# Intel<sup>®</sup> Pentium<sup>®</sup> III Processor Specification Update

Release Date: September 2002

Document Number: 244453-044

The Pentium<sup>®</sup> III processor may contain design defects or errors known as errata which may cause the product to deviate from published specifications. Current characterized errata are documented in this Specification Update.

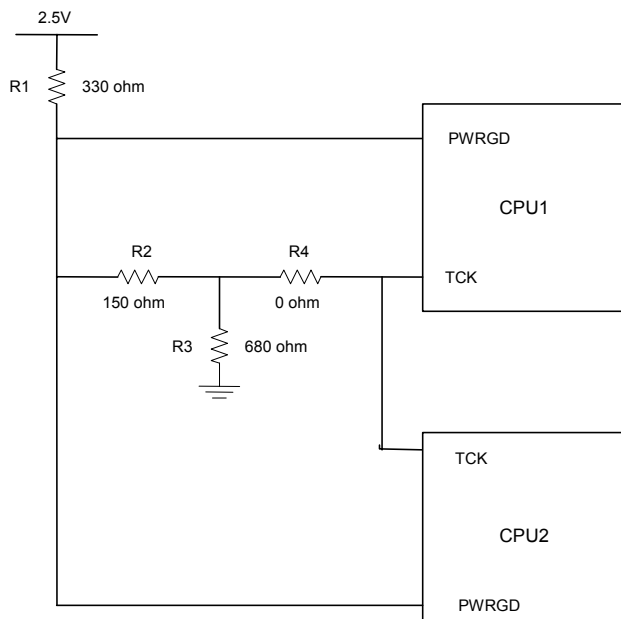
**Problem:** The internal control register bit responsible for operation of the Thermtrip circuit functionality may power up in a non-initialized state. As a result, THERMTRIP# may be incorrectly asserted during de-assertion of RESET# at nominal operating temperatures. When THERMTRIP# is asserted as a result of this erratum, the processor may shut down internally and stop execution but in few cases continue to execute.

**Implication:** This issue can lead to intermittent system power-on boot failures. The occurrence and repeatability of failures is system dependent, however all systems and processors are susceptible to failure. In addition, the processor may fail to stop execution during the event of a valid THERMTRIP# assertion resulting in the potential for permanent processor damage.

**Workaround:** To prevent the risk of power-on boot failures or catastrophic thermal failures, a platform workaround is required. The system must provide a rising edge on the TCK signal during the power-on sequence that meets all of the following requirements:

- Rising edge occurs after Vcc\_core is valid and stable
- Rising edge occurs before or at the de-assertion of RESET#
- Rising edge occurs after all Vref input signals are at valid voltage levels
- TCK input meets the Vih min and max spec as mentioned in EMTS
